VCSEL reliability comparison

Rubén Pérez-Aranda, KDPOF
David Ortiz, KDPOF

Overview

850nm 25G VCSEL Characterization Bandwidth Performance Over Temperature

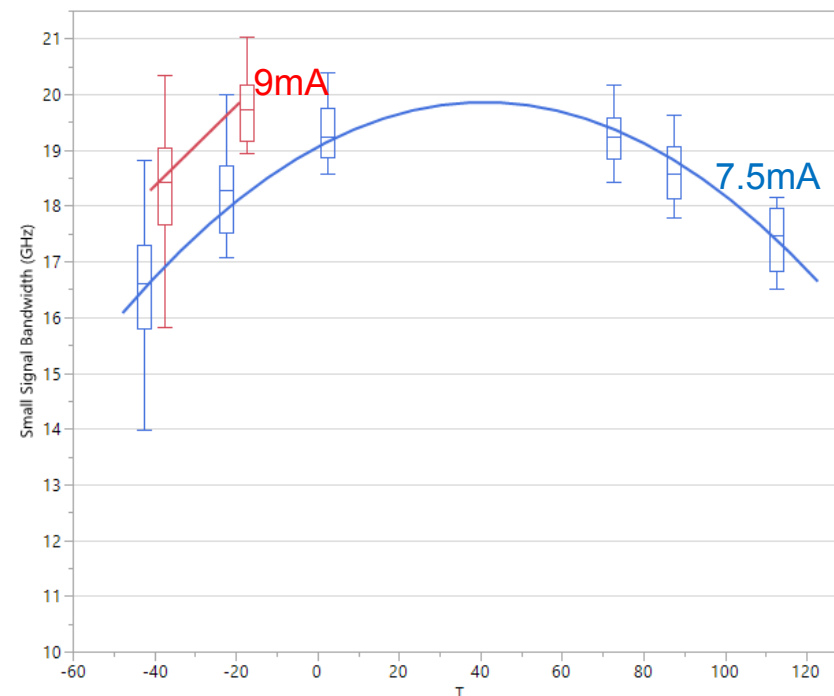
- Small signal bandwidth is an important parameter, however it is not sufficient for feasibility assessment
 - Different combinations of extrinsic pole, resonance frequency and damping rate can produce the same small-signal BW
- It is very important to characterize the non-linear large-signal response of VCSEL, specially in extreme temperatures (-40 and 125°C) as well as the RIN
 - Non linearity and damping-ratio (resonance below Nyquist frequency) are critical, specially for 25 Gb/s NRZ and 50 Gb/s PAM4
 - RIN can degrade significantly in cold and hot temperatures
- VCSEL devices with the same small-signal bandwidth can produce very different time-domain eye diagrams and reliability performance
- **More detailed characterization data for T_s between -40 and +125°C would be appreciated**

850nm 25G VCSEL Reliability Requirement

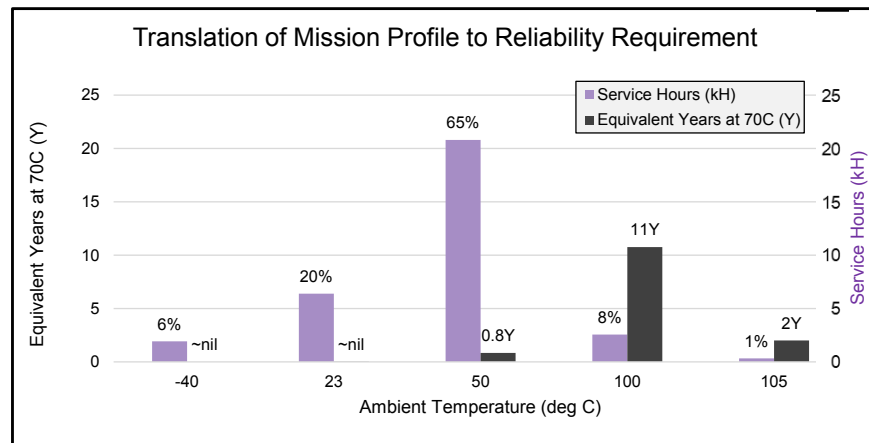
- IEEE P802.3cz has considered AEC-Q100 Grade 2 ($T_{AMB-ECU}$ from -40°C to +105°C) as reference for nGBASE-AU PHY qualification with delta $T_{AMB-ECU}$ to T_J CMOS die of 20 °C, according to experience with 1 Gb/s PHYs in series production
- Delta between $T_{AMB-ECU}$ and T_J is very determined by heat dissipation of others ICs sharing the same PCB, the density of components and the enclosure without forced air (i.e. no convection)
- nGBASE-AU PHYs are expected to be integrated with high density in size constrained ECUs, as it is usual in automotive, therefore a very different scenario of data-centers
- Si CMOS die (PHY electronics) T_J will be similar to photonics T_s (substrate), expecting the maximum photonics T_J to be much higher than 125°C
- **Information supporting the use in reliability assessment of $T_{AMB-ECU}$ to T_s of only 10 °C would be appreciated**

- Acceleration factors can be calculated based on reliability model (Arrhenius's Eq for absolute temperature)
- Assumed that Ea = 1.15 eV is given in terms of T_J, as it is generally the case
- T_J is calculated using data from other InGaAs 850nm 25G VCSEL providers [1]
- There is a big dependency with T_{AMB} to T_S delta; results are given for 20 and 10 °C using same mission profile of [4]
- More restrictive results are obtained
- 32kH Automotive mission profile corresponds to ~42Y at 70°C (substrate)
- T_J data would be appreciated for cross checking

High Temperature Operating Life

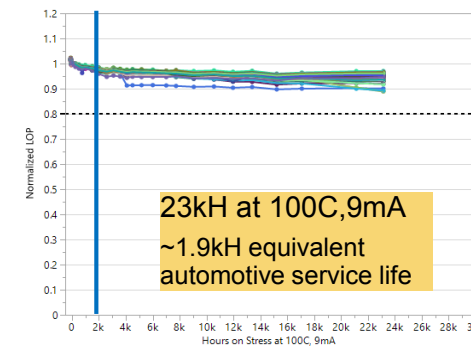
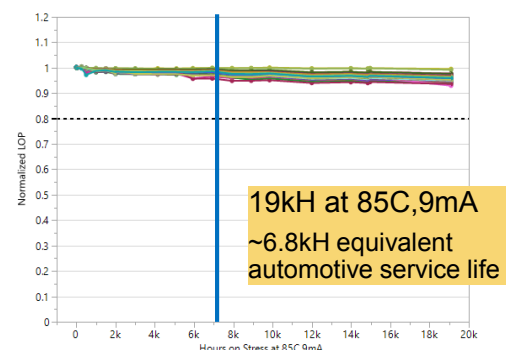
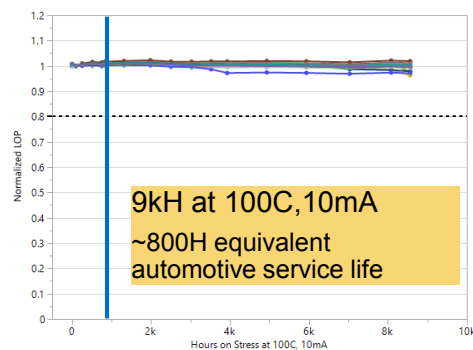
- Using VCSEL reliability model, we can calculate E_a and n from the reported data
- Calculated **$E_a = 1.044 \text{ eV vs. } 1.15 \text{ eV}$**
 - E_a is in the exponent of Arrhenius's Eq, so reliability is very sensitive to this parameter
- Calculated **$n = 8.2 \gg 1.64$** in [1] for other 850nm 25G VCSEL
 - Possible root cause may be current density over stress, producing extra current acceleration factor not consistent with actual operation condition
- More visibility on test matrix and n fitting would be appreciated**

Reliability comparison — 160 ppm (5 FIT)

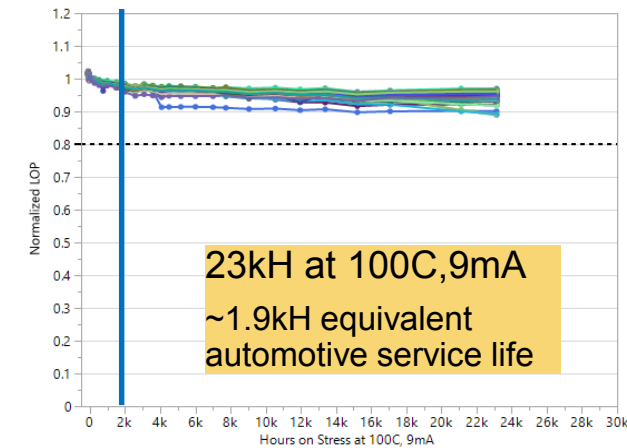
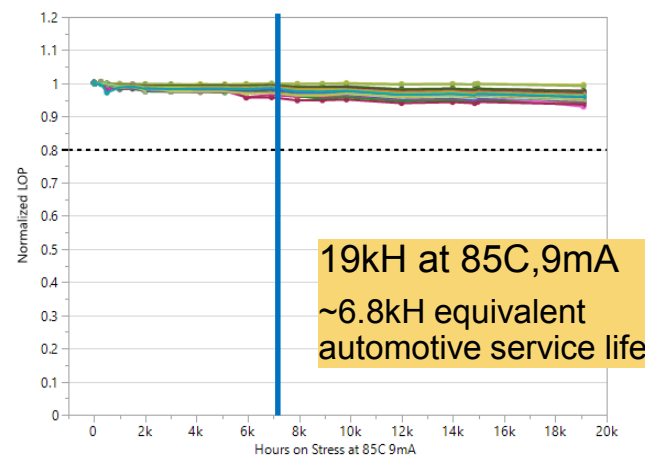
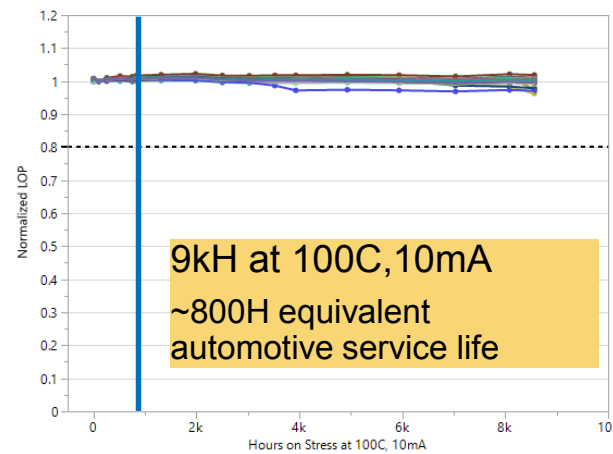
**850nm VCSEL of [4] has similar reliability
of 850nm VCSEL of [1, 2, 3]**

**Consistent with currently considered
data for 850nm 25G VCSELs [1, 2, 3], still
insufficient for automotive**

850nm vs 980nm reliability comparison

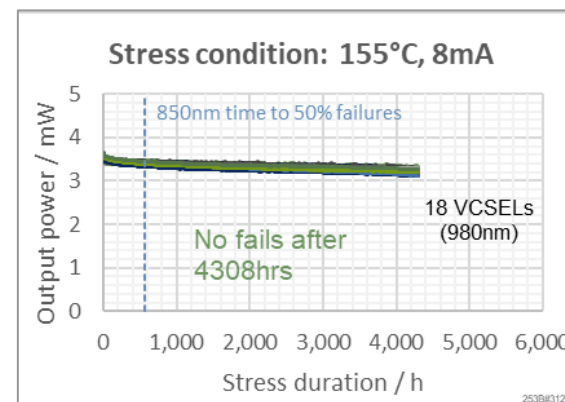
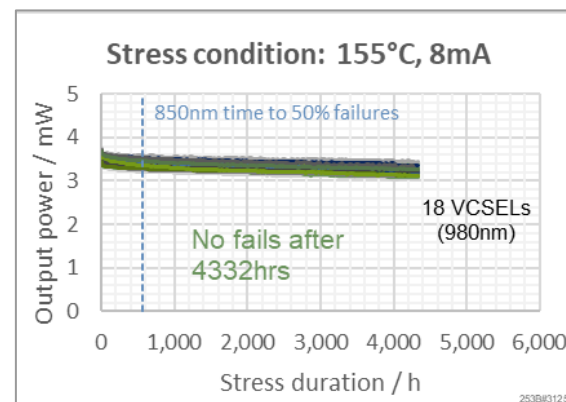
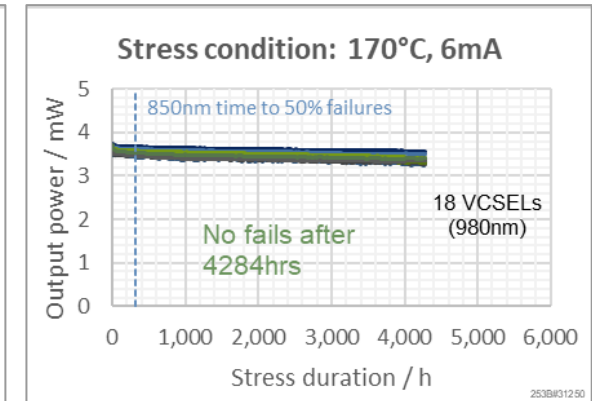
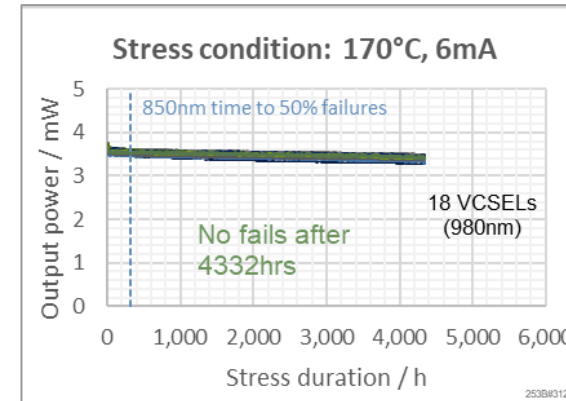
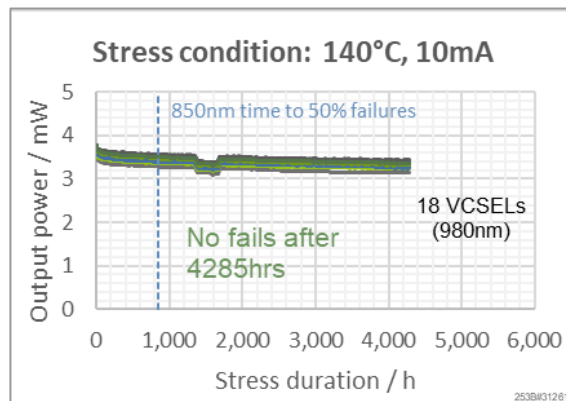
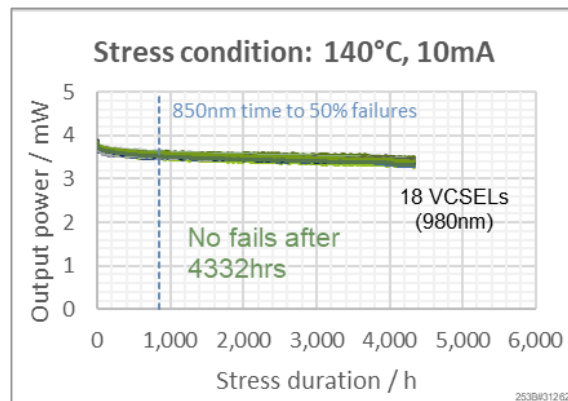
In [4], stress conditions do not cover operation, i.e. $< T_s = 125^\circ\text{C}$

In [3], stress conditions exceed operation
